May 8, 2024

**Re: Response to Completeness Review  
Project No. P2023-055  
Landing Court | APN 153-162-70**

Attachment: Marin County Flood Control District Maps

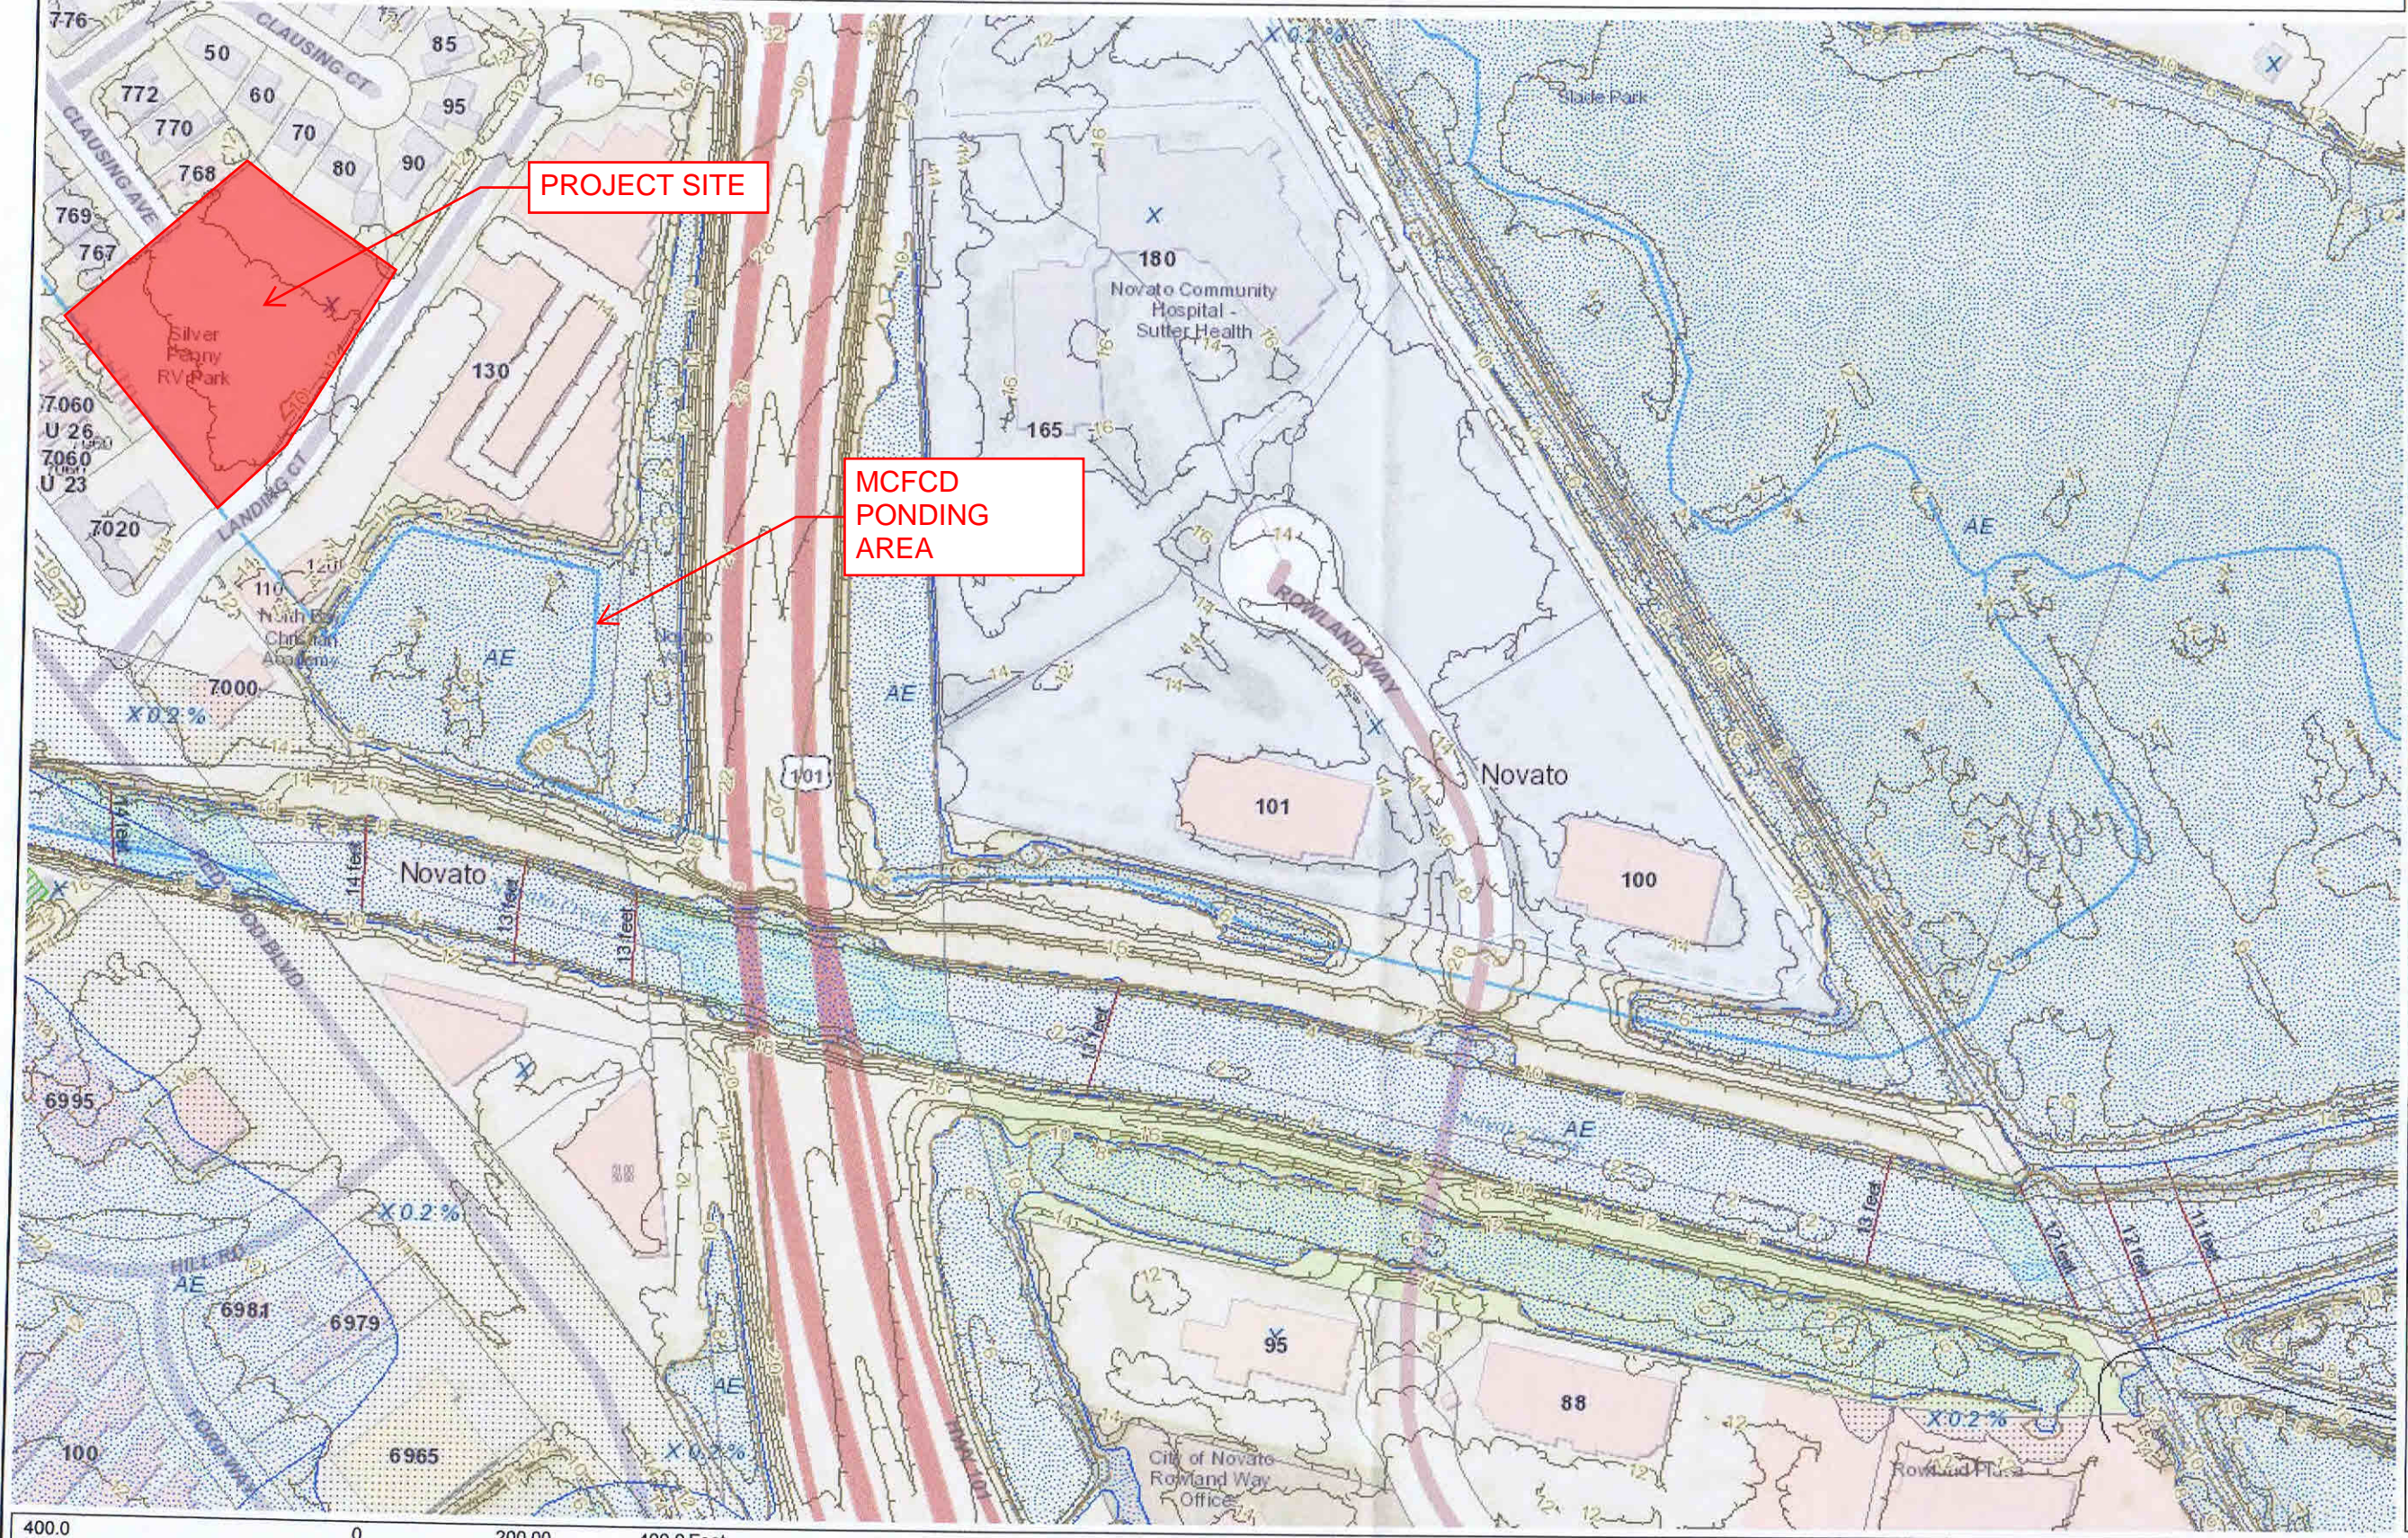
In addition, we understand based on previous meetings with city staff in 2020, that there was a concern the project site may experience flooding during large storm events. In response to this concern, we have reviewed the attached Marin County Flood Control District Maps and determined our site is not in a flood hazard zone. The storm drain system from our site ultimately discharges via a 48" outfall to a Marin County Flood Control District ponding area that is southeast of our site. Based on the attached as-built, the flood elevation of the ponding area is at elevation 10.0. The proposed building's finished floor elevation is 13.4 and the lowest catch basin rim elevation is at 12.0. Our site is a minimum of 2.0-ft above the downstream flood plain, and therefore, the proposed site will not flood during large storm events.
